From: Shelby S <sheehan.shelby@gmail.com>
Sent: Monday, December 18, 2023 1:56:46 PM
To: Trish Spencer <tspencer@alamedaca.gov>; Tony Daysog <tdaysog@alamedaca.gov>; Malia Vella <mvelle@alamedaca.gov>; tjensen@alamedaca.gov <tjensen@alamedaca.gov>; City Clerk <clerk@alamedaca.gov>; Historical Board <historicalboard@alamedaca.gov>
Subject: [EXTERNAL] Comment for upcoming City Council Meeting RE CEQA Compliance.

From: [Shelby S](#)
To: [Andrew Thomas](#)
Cc: [Abby Thorne-Lyman](#); [Trish Spencer](#); [Malia Vella](#); [Tony Daysog](#); [City Clerk](#); [Jennifer Ott](#); [Christopher Seiwald](#); [Keith Mccoy](#); [Rachel de Ivanov](#)
Subject: Re: [EXTERNAL] RE today's CC Item 7F--Radium infill--what about the Specific Plan? Doesnt anyone read it?
Date: Tuesday, December 5, 2023 1:27:34 PM
Attachments: [image001.png](#)

From: [Shelby S](#)
To: [Abby Thorne-Lyman](#); [Andrew Thomas](#); [Trish Spencer](#); [Malia Vella](#); [Tony Daysog](#); [City Clerk](#)
Subject: [EXTERNAL] RE today's CC Item 7F--Radium infill--what about the Specific Plan? Doesnt anyone read it?
Date: Tuesday, December 5, 2023 10:15:51 AM
Attachments: [image.png](#)
[image.png](#)
[image.png](#)
[image.png](#

2. Building 77: Height 42 feet

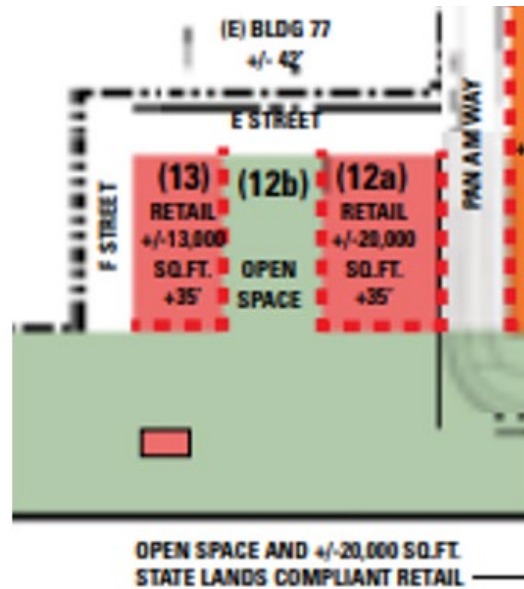
"To maintain this historic seaplane passenger terminal's visual relationship to the Seaplane lagoon the plan recommends that a view corridor of a minimum of 120 feet in width be maintained on the centerline of the building. This "Historic Easement" /view corridor should be developed as a public park or plaza, and may contain (not "shall contain--we could leave it open) small one story pavilions or landscaping that will support public use and enjoyment of the space while allowing the visual connection between the Building 77 and the water to be maintained." (p.136)

1. The Project rendering looks like this:

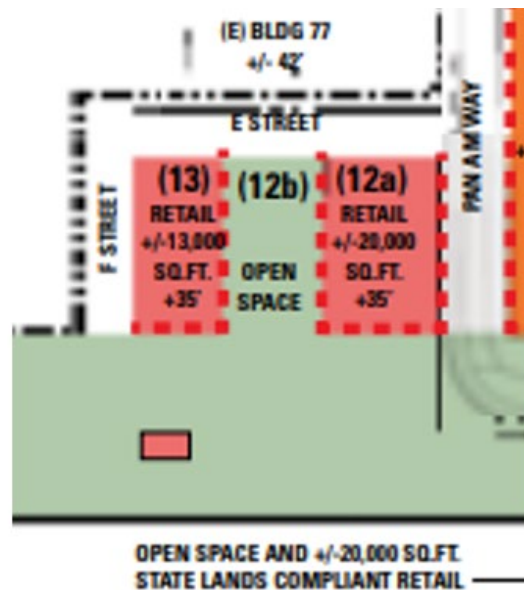
--> this proposed "pavilion" is blocking over 50% of the "centerline view" from Building 77 that is supposed to be maximized. This is a discretionary project, and the City Council doesn't have to approve anything here. PLEASE STOP RUINING THE VIEWS.

Now this proposal is a huge out of scale permanent building that violates the land use plans and is a view megablocker. BUT WHY?

Can you even find Building 77?

2. Heres a corner snippet I found that shows the proper scaling in front of Building 77 (p. 126)--does the above rendering look like it complies?:

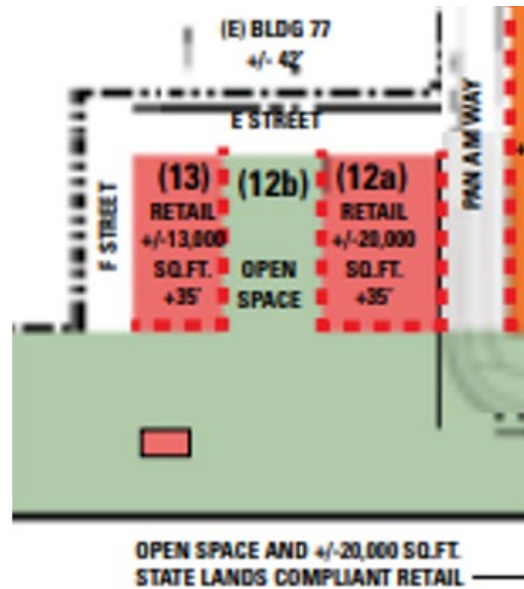
3. Per the RFP response (p11, referencing the Site A Development Plan)--The height limit for new buildings in front of Building 77 is **MAXIMUM 35 feet.**

You can also see the "Historic Easement" is encroached with this Plan.
